Biotronik, Inc.

Entovis ProMRI Pacemaker System Labeling and Programmer Software Version PSW 1307.U

PURPOSE OF SUBMISSION

Home Monitoring Trending of Atrial and Ventricular Threshold post-MRI

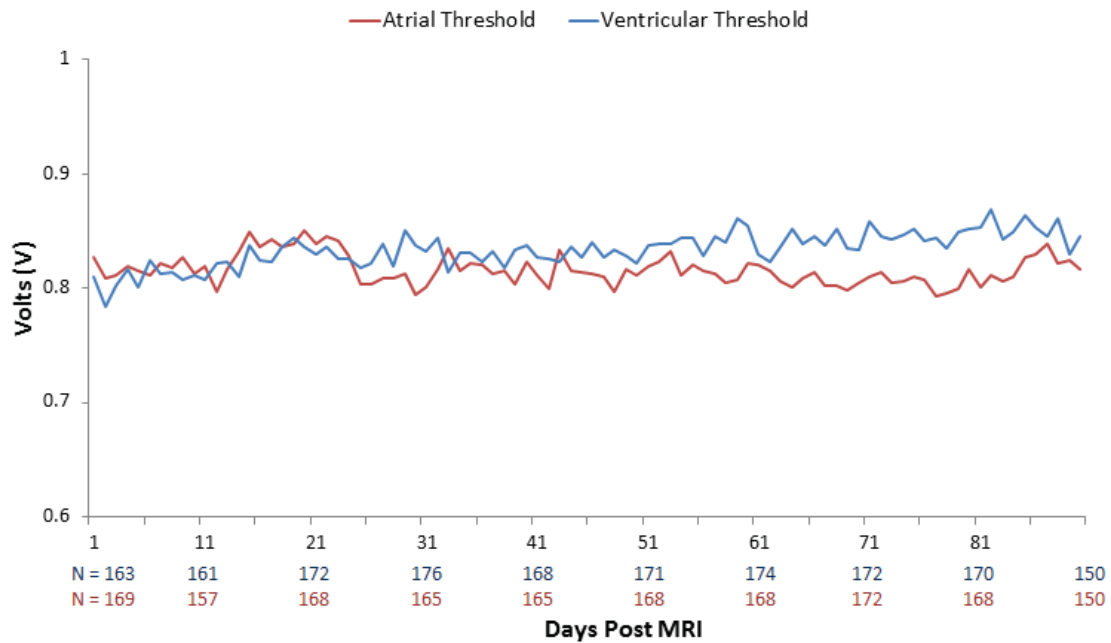
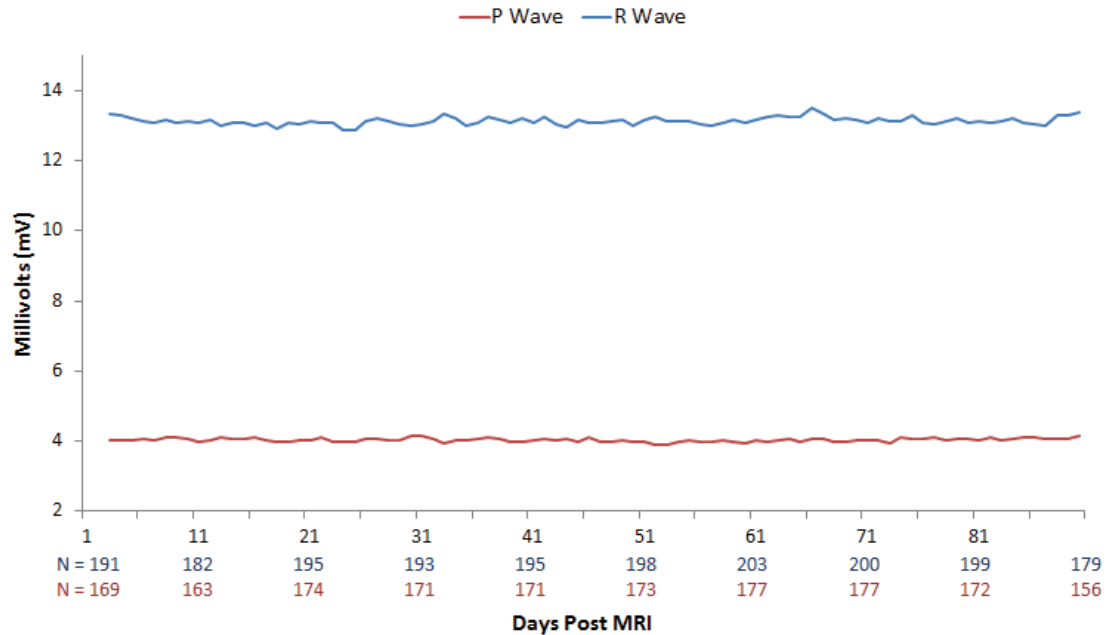
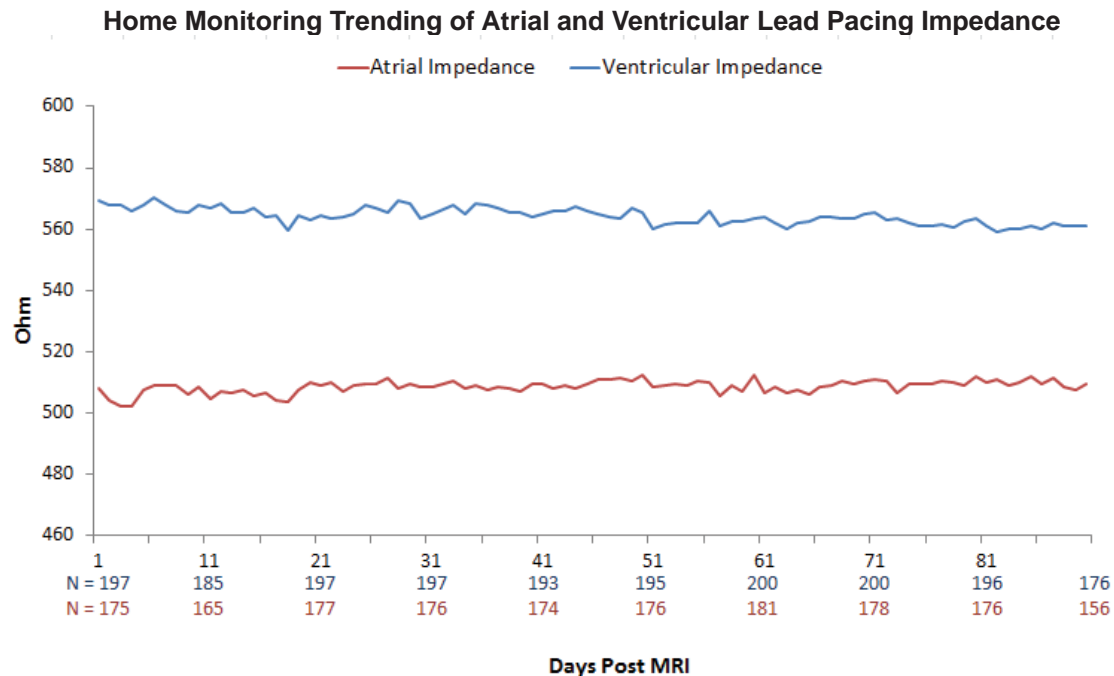
Question #5: In Section 2.6.8 Home Monitoring Trending of the clinical report (page 1862 of the submission), you provided an average of the trend data obtained during the study. While this presentation is helpful, FDA is unable to evaluate the changes in pacing capture thresholds, sensing values, or impedance values in individual patients, either related to the MR scan or normal variations independent of the MR scan. FDA believes that more detailed analyses would help to demonstrate the performance of your pacemaker system following MR scans. Please provide an analysis and presentation of individual patient data along with a comparison of how the data provided through Home Monitoring compared to data collected during in office visits.

5. In Section 2.6.8 Home Monitoring Trending of the clinical report (page 1862 of the submission), you provided an average of the trend data obtained during the study. While this presentation is helpful, FDA is unable to evaluate the changes in pacing capture thresholds, sensing values, or impedance values in individual patients, either related to the MR scan or normal variations independent of the MR scan. FDA believes that more detailed analyses would help to demonstrate the performance of your pacemaker system following MR scans. Please provide an analysis and presentation of individual patient data along with a comparison of how the data provided through Home Monitoring compared to data collected during in office visits.

The firm provided the following additional analyses as part of the interactive response (part 1 of 2, March 7, 2014).

The following six charts are histograms of per-patient pacing threshold data, sensing amplitude data and lead impedance data. Each plot contains a histogram of the difference between the 1-month (1M) office visit data and the Pre-MRI data (blue bars), as well as a histogram of the difference between the mode of the Home Monitoring data (HM Mode) and the Pre-MRI data (red bars). The mode is the most commonly occurring value during the 30-days between the MR scan and the 1-month follow-up, based on daily lead measurements (~30 measurements per patient). Using the mode eliminates the variability made in any one lead measurement, at a given 1-month follow-up.

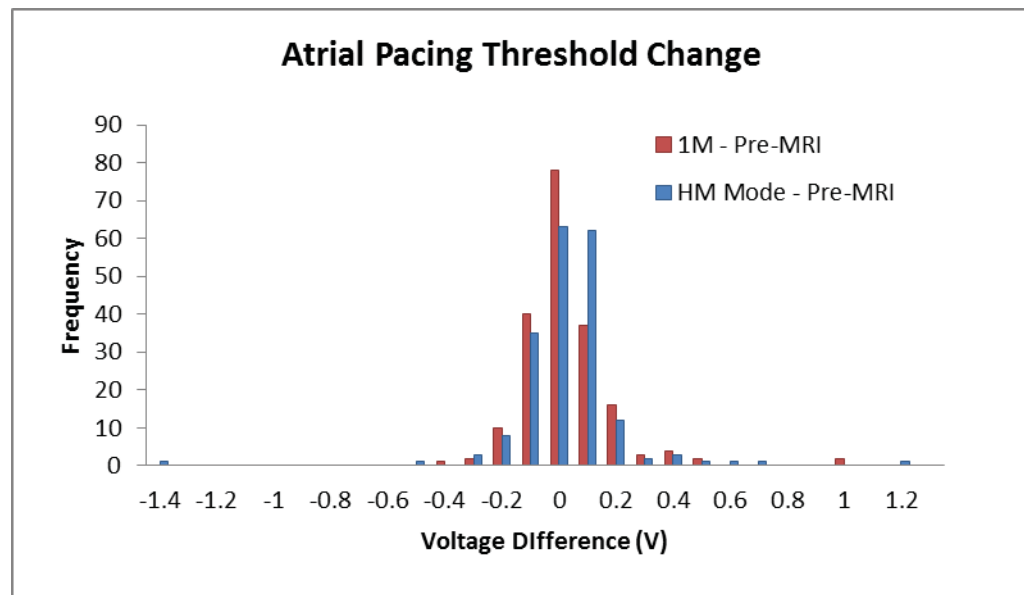
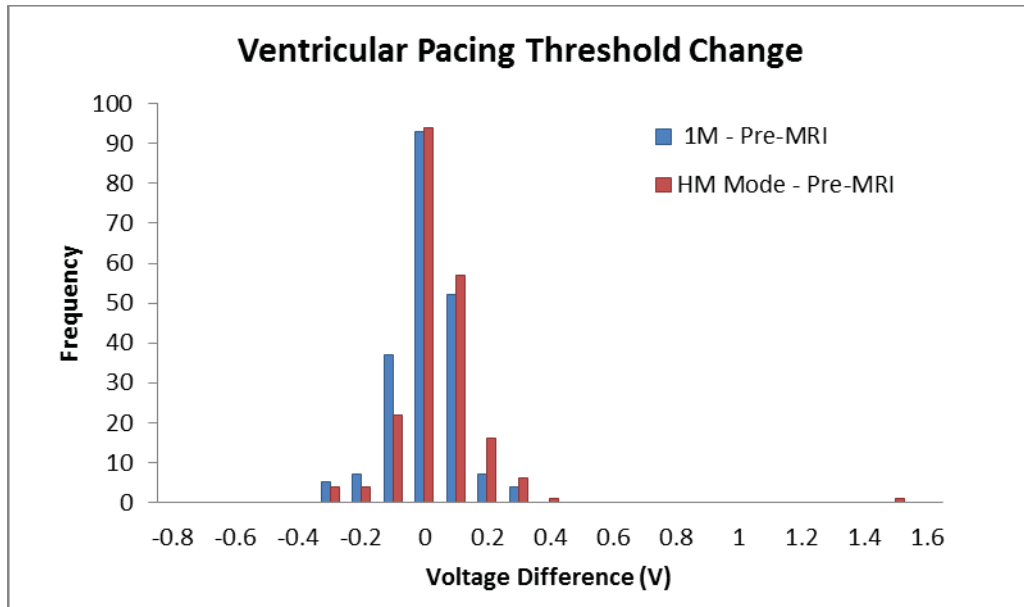
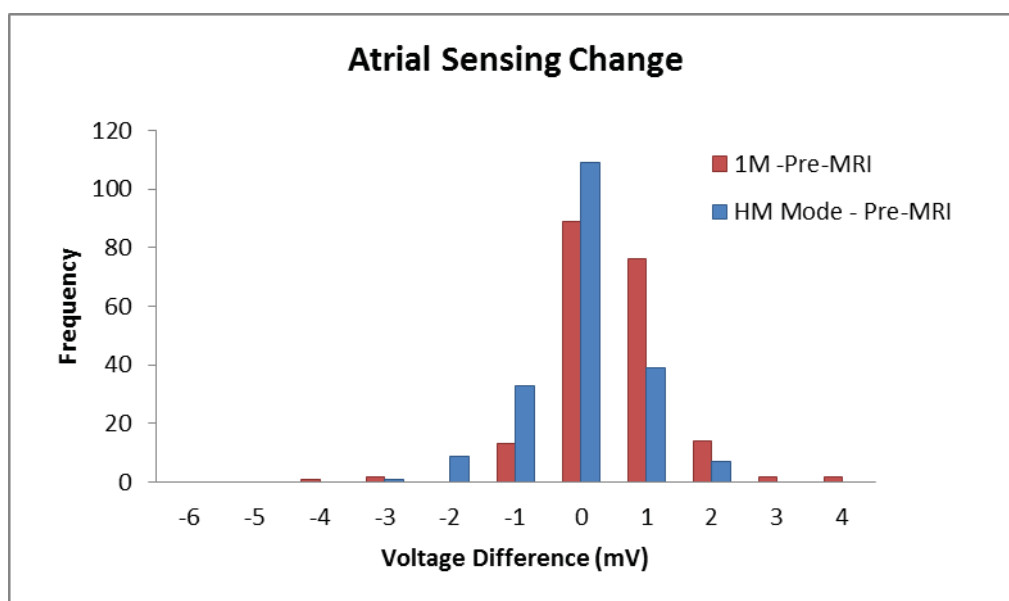
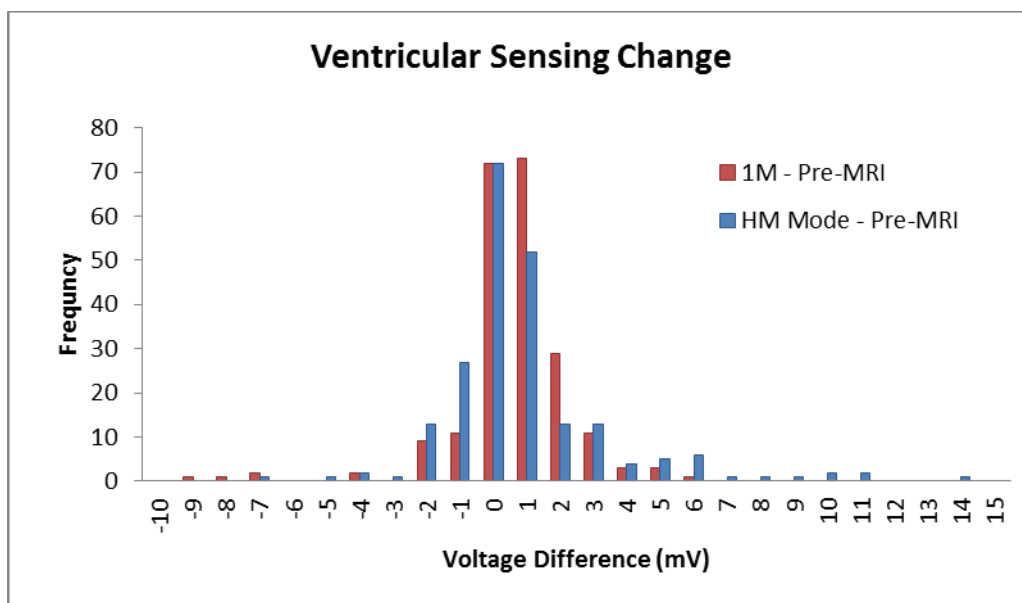
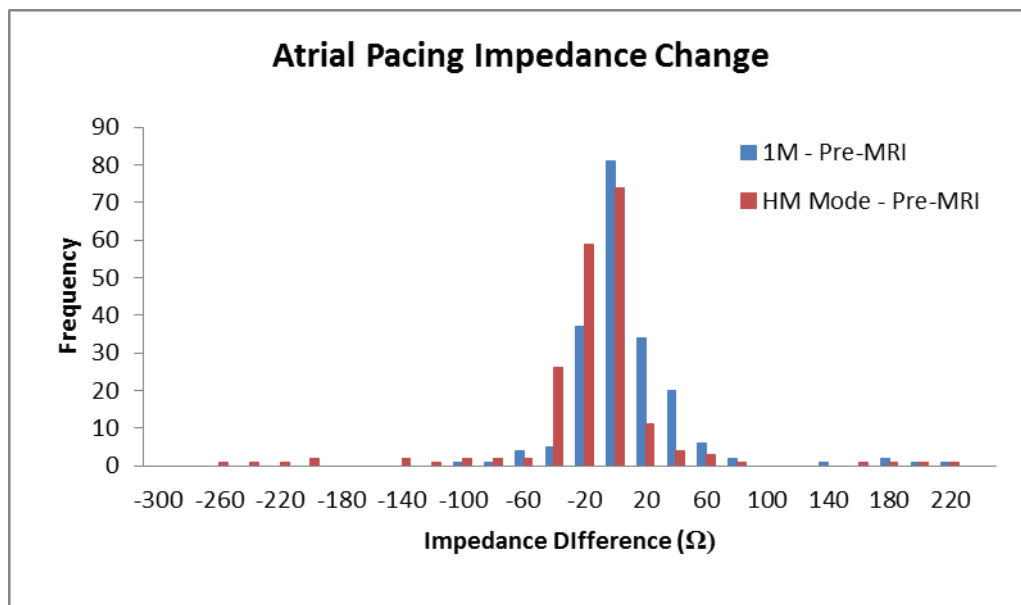
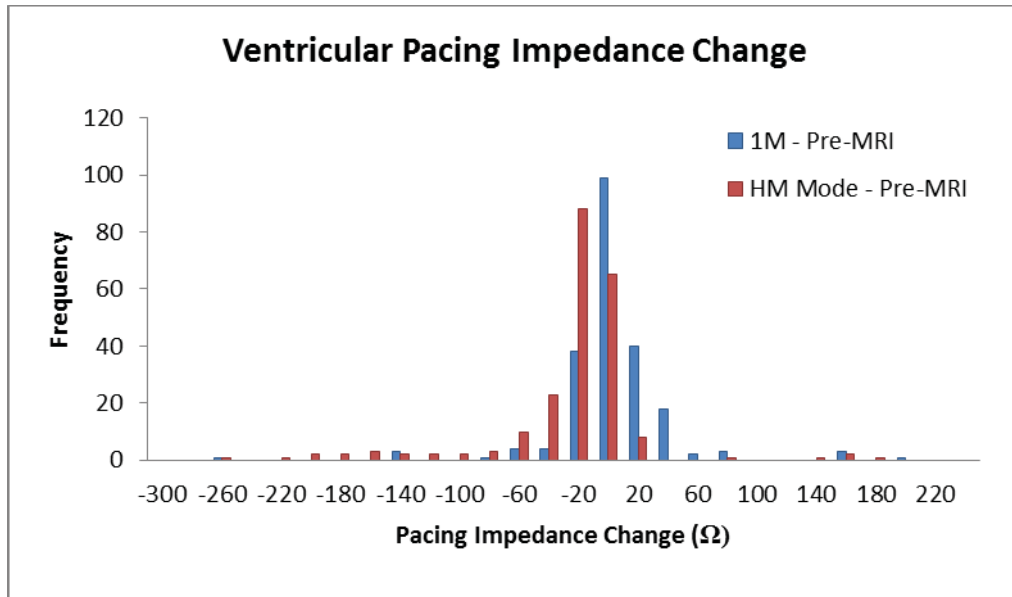
Brian Lewis provided his review of the firm's initial responses. From his perspective, the firm's responses are sufficient to address his concerns. He asked for clarification about the data presented for interactive clinical question #5. I forwarded his question to the firm on March 20, 2014. The firm confirmed that the data was analyzed in the way that Brian Lewis' had assumed.

The similarities in the histograms of per-patient pacing threshold, sensing amplitude or lead impedance changes post MRI, demonstrate that these changes in individual patients are likely normal variations independent of the MR scan. Furthermore, the Home Monitoring data is consistent with the in-office threshold measurements demonstrating that this surveillance method could be used to closely monitor patients following MR scans.

FDA believes that this additional data, beyond the data collected and presented in support of the pre-defined study endpoints, further supports a reasonable assurance of safety and effectiveness of the pacemaker system when used in an MR environment.

In response to Brian Lewis' question about the histogram data for interactive clinical question #5, I sent an email to the firm asking them to confirm their analysis method. The firm confirmed that the data was analyzed in the way that Brian Lewis' had assumed.
